Mahasti Pourdastan
Executive Director
Federal Regulatory

February 11, 2008

Thank you for inviting us to provide comments on the ENERGY STAR program requirements for Service Providers and Manufacturers of Set-top Boxes (STBs). Based on the review of the draft 3 of the ENERGY STAR STB technical specifications, the meeting on February 1, 2008 in Washington D.C., and the follow-up conference call on February 5, 2008, below are Verizon's comments on three issues:

3. **Optical Network Terminal (ONT)**

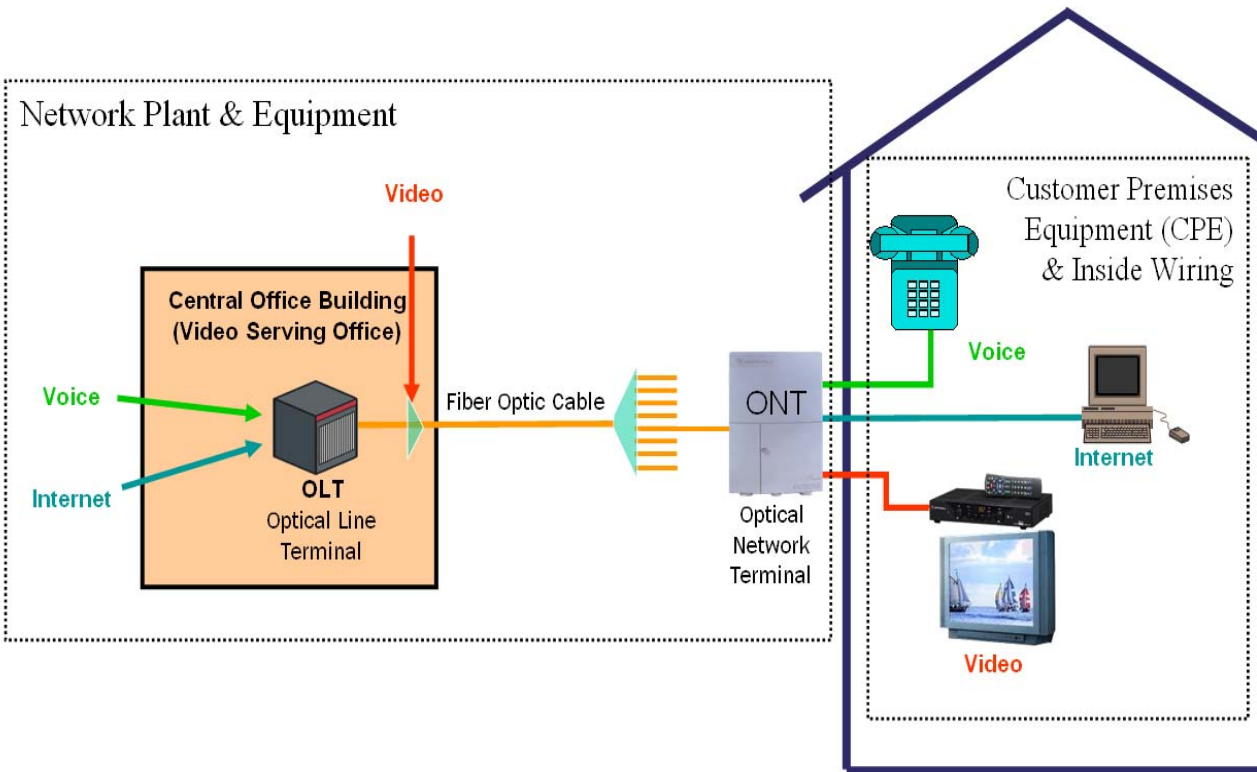
As we discussed at the 2/1 meeting, as well as on the 2/5 call, the ONT is an integral part of Verizon's FiOS network, much more analogous to the neighborhood nodes used by cable operators in the hybrid-fiber-coaxial networks than to the STBs those providers' deploy. It is at the ONT – typically attached to the side of a subscriber's home – that Verizon's fiber network terminates so that all services delivered over the fiber network may be translated from the optical signals to electrical signals that are delivered to the customers' home equipment (*e.g.*, telephones, computers, routers, STBs, television sets). The ONT's place in Verizon's network architecture is reflected in the following diagram.

As this makes clear, the ONTs deployed by Verizon are an integral piece of network equipment, much more similar to the nodes used by traditional cable operators, and should not be considered a STB for purposes of the EPA's Energy Star standards.
